**RE: Zoning Committee Staff Report File #12-101937**

Re: REEMO GAS AND DELI  
1200 Rice Street  
Site Plan Review Application.

## Tom Beach - Site plan for rebuild of Reemo Gas and Deli at 1200 Rice

GRADING, DRAINAGE, EROSION CONTROL & UTILITY PLAN  
 REEMO GAS & DELI  
 CITY OF ST. PAUL

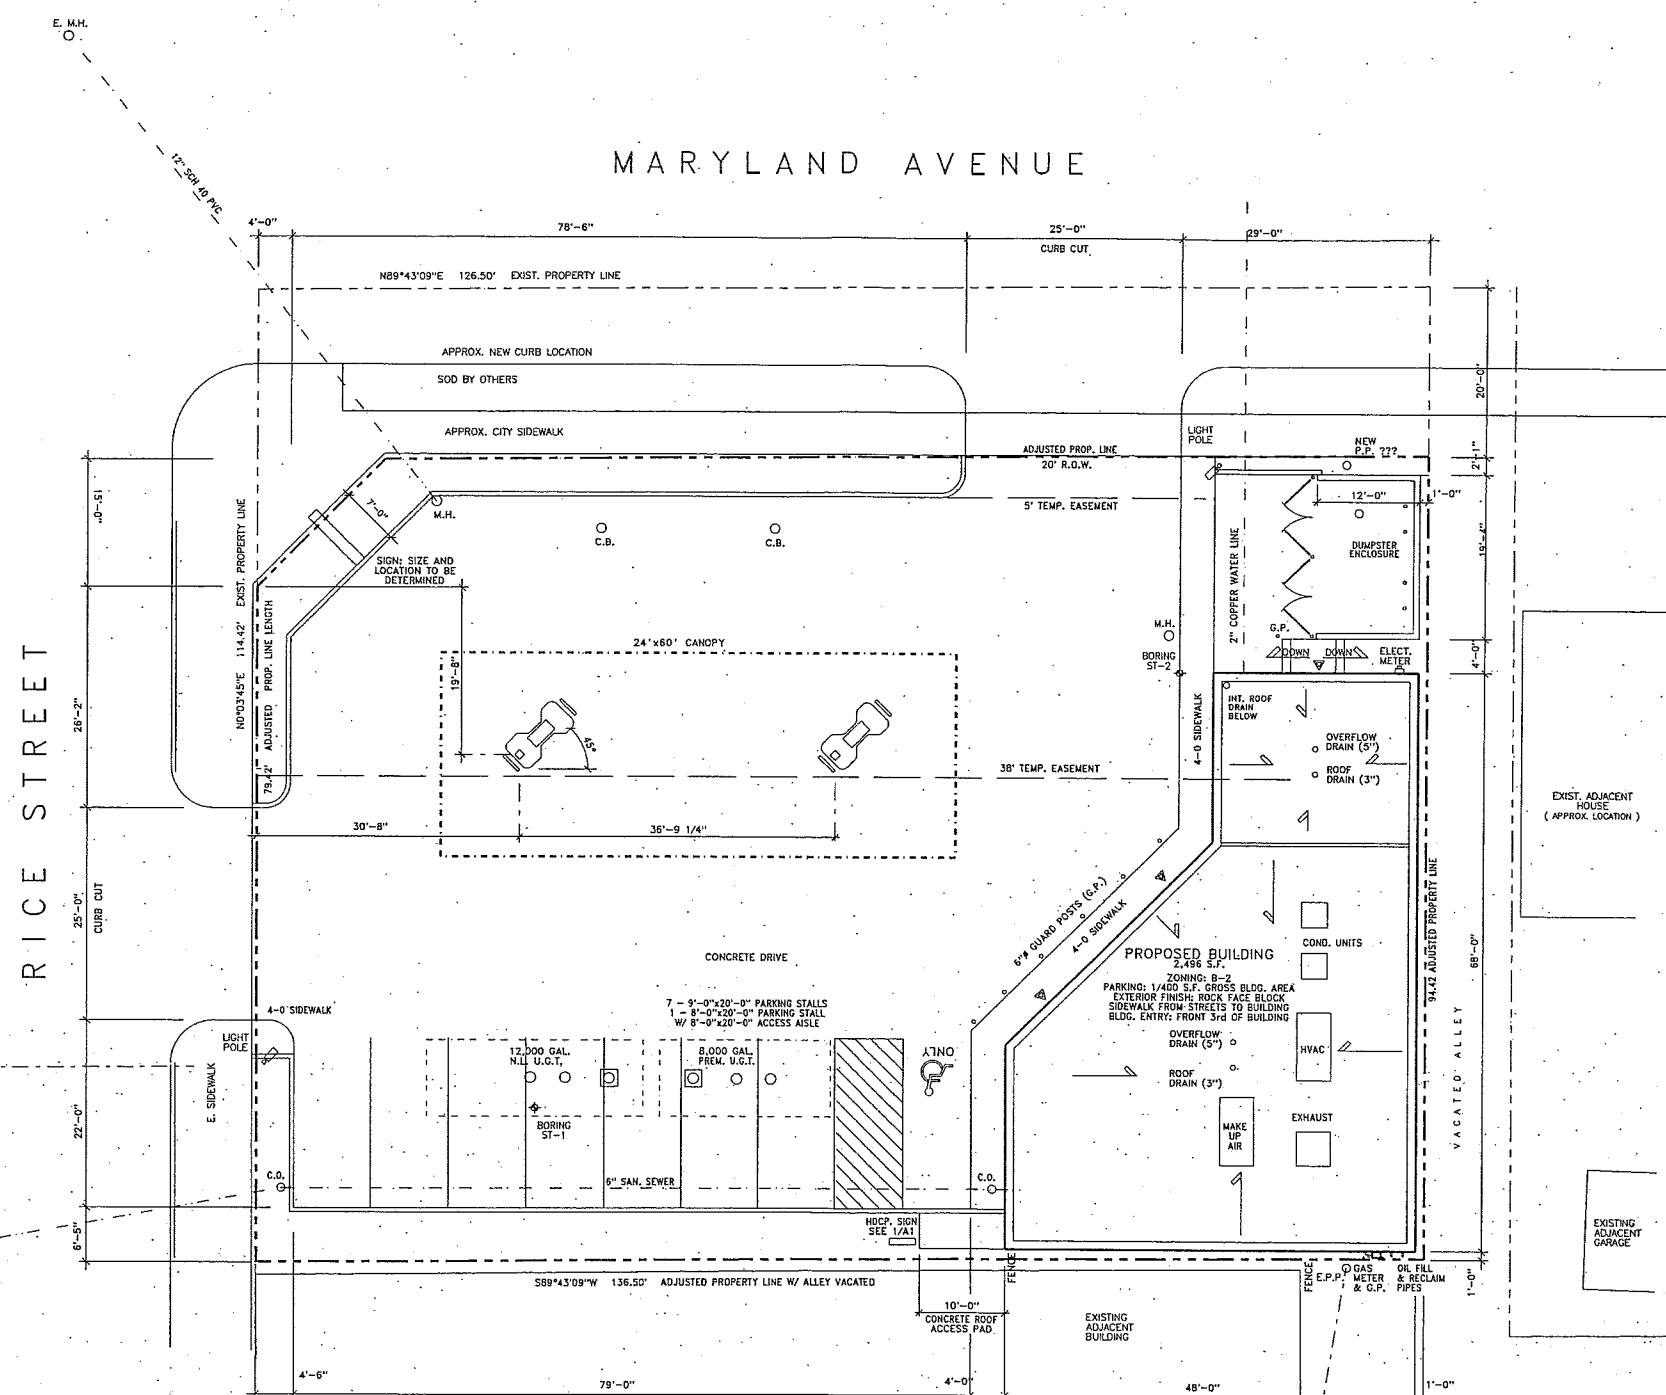
- 1) Provide the following on Plan Sheet C1 under UTILITY NOTES:
  - a) Revise Note 4 to read: "Maintain 8 feet of cover over all water services."

1) Provide the following on Plan Sheet C1 under UTILITY NOTES:

- a) Revise Note 4 to read: "Maintain 8 feet of cover over all water services."
- 2) The following work shall be performed by SPRWS on an actual cost basis. An estimate will be provided and a deposit in the amount of the estimate must be received before the work can be scheduled. Work of this type is currently being scheduled 4 - 6 weeks after payment and required signatures have been received.
  - a) Cut offs of existing unused services at the main. Excavation and restoration by contractor.
  - b) Installation of services in right of way.

Please correct these notes on Sheet C1

Note 6 – The correct name of the contact person is Long Yang.

Notes 15 and 19 – Please replace with this standard note:
